# CITY OF PORTLAND

Job ID: 2012-06-4359-CH OF USE

**Jeanie Bourke - RE: 56 Hammond St BP#2012-06-4358 & 4359 plan review comments**

Project Title: Hammond Street Apartments

**SK-2**

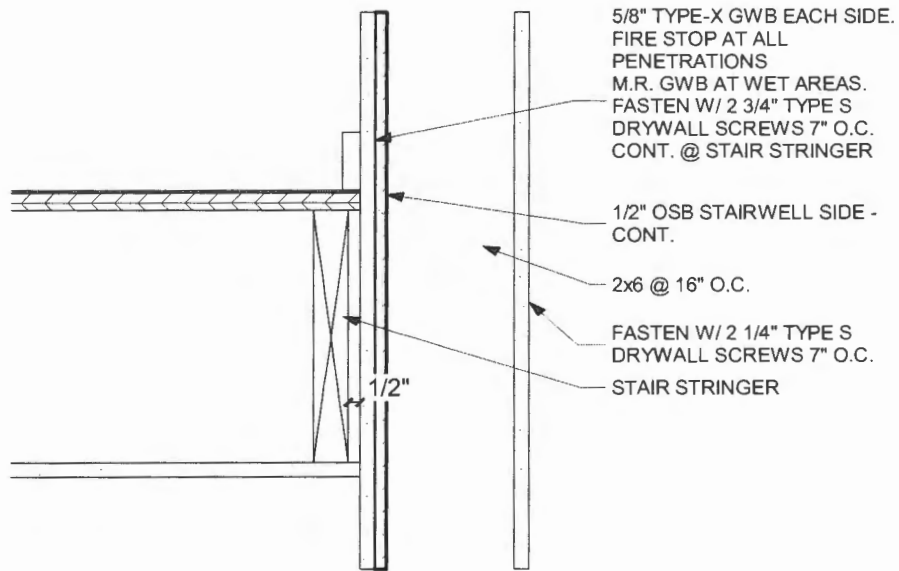
· Provide justification for the .5 hour ceiling type (2 clg) on Plan A000 per IBC Sec. 712.3  
*Section 709.3 exception 2 allows a rating of 1/2 hour in buildings of type VB construction equipped with an automatic sprinkler system. This assembly rendered moot by your question regarding sound transmission below. See attached SK-2 drawing defining new assembly.*

· Provide W/C assembly compliance for sound transmission per IBC Sec. 1207

REPLACE WALL TYPE 1-B AT STAIRWELL AND HALL WITH ASSEMBLY BELOW. RESILIENT CHANNEL TO BE APPLIED TO APARTMENT UNIT SIDE OF ASSEMBLY. 1/2" OSB TO REMAIN ON STAIR SIDE OF WALL PER STRUCTURAL DRAWINGS.

<b>1 Hour</b> FIRE	Design #	GA File #	<b>STC - 50</b>	
	<b>UL U311</b>	<b>WP 3241</b>	Sound Test #	TL-93-196
		<p>Resilient furring channels attached 24" o.c. horizontally to one side of 2x4 wood studs 16" or 24" o.c. with 1-1/4" type W screws. 1/2" x 3" gypsum board filler strips attached to floor and ceiling plates with 1-1/4" type W screws 3'-0" o.c. 5/8" (15.9 mm) Fire-Shield C Gypsum Board applied horizontally to channel with 1" type S screws 12" o.c. on all edges and intermediate channels and attached to top and bottom plates with 1-7/8" type S screws 12" o.c. Vertical butt joints between studs back-blocked with 20" long piece of resilient channel. 5/8" (15.9 mm) Fire-Shield C Gypsum Board applied horizontally on opposite side directly to wood studs with 1-1/4" type W screws spaced 12" o.c. Horizontal joints in line, vertical joints staggered each side. Mineral wool insulation 3" thick friction fit between studs.</p>

REPLACE CEILING TYPE 2-CLG WITH ASSEMBLY BELOW.

<b>1 Hour</b>	Design #	GA File #	<b>STC - 53</b>	<b>IIC - 46</b>
	<b>N/A</b>	<b>FC 5241</b>	Sound Test # TLF-02-043a	Test # 02-027
		<p>Base Layer 1/2" (12.7 mm) Fire-Shield C Gypsum Board applied at right angles to resilient furring channels with 1-1/4" Type S drywall screws 12" o.c. Resilient furring channels applied at right angles to joists and spaced 16" o.c. with 1-1/4" Type W drywall screws to wood I-joists 24" o.c. Face layer 1/2" Fire-Shield C Gypsum Board applied at right angles to channels with 1-5/8" Type S drywall Screws 12" o.c. Face layer end joints located midway between channels and attached to base layer with 1-1/2" Type G screws 12" o.c. Edge joints offset 24" from base layer edge joints. Wood I-joists supporting 5/8" oriented strand board applied at right angles to I-joists with 8d common nails 12" o.c. Sound test with 3-1/2" mineral wool or fiberglass insulation in joist cavity.</p>

South Elevation

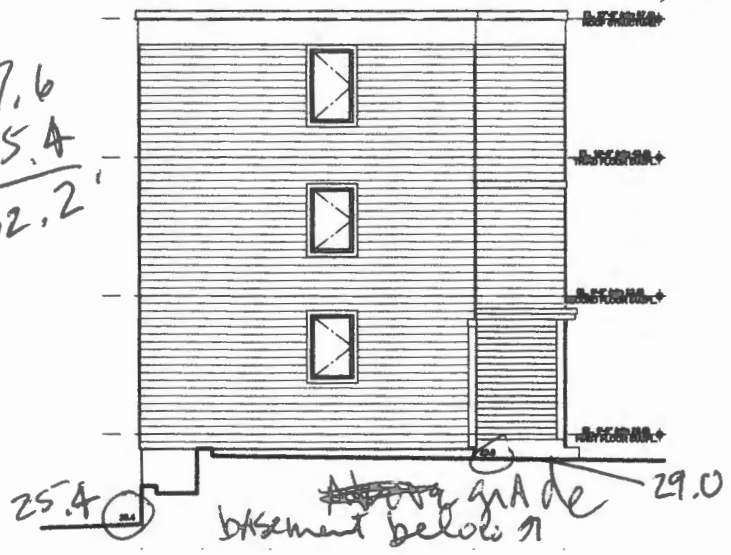
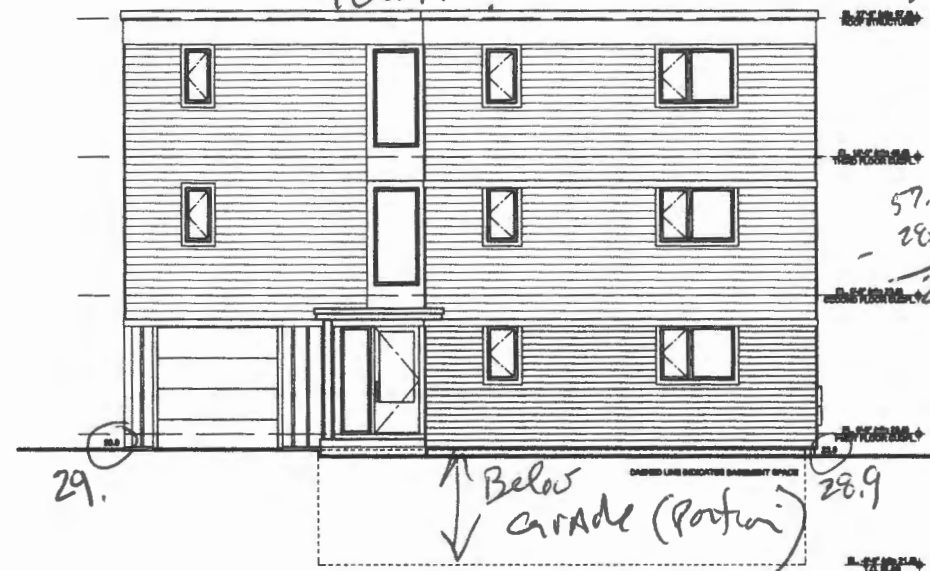
I have reviewed the submittal information. Generally, all the R-6 zone requirements are being met. However, I will need scaleable building elevations to (a) determine building height compliance and (b) determine the number of stories of the building. To complete this review I will also need the post grade elevations around the building to average the grade in order to determine the average grade and the beginning point of measuring height. Then I will need the elevation to the top of the structural beam of the roof structure. To determine the official number of stories, I will need information showing the percentage of the lower level and how it relates to the average level of the adjoining ground. That level shall be counted as a story for the purpose of measurement where more than one-half of its height is above the average level of the adjoining ground (in the definitions 14-47).

**2/22/2012** I reviewed the most recent download dated 2/15/2012. The applicant forwarded the information that I needed to determine the number of stories by definition and to confirm the actual building height of both buildings.

My calculations indicate that both buildings are considered to be three story buildings by definition and may use the setbacks as indicated on the site plan. I have also determined that both buildings are well under the maximum building height of 45' in the underlying R-6 zone.

3 Store for zoning purposes

$$\begin{array}{r} 57.6 \\ -25.4 \\ \hline 32.2 \end{array}$$
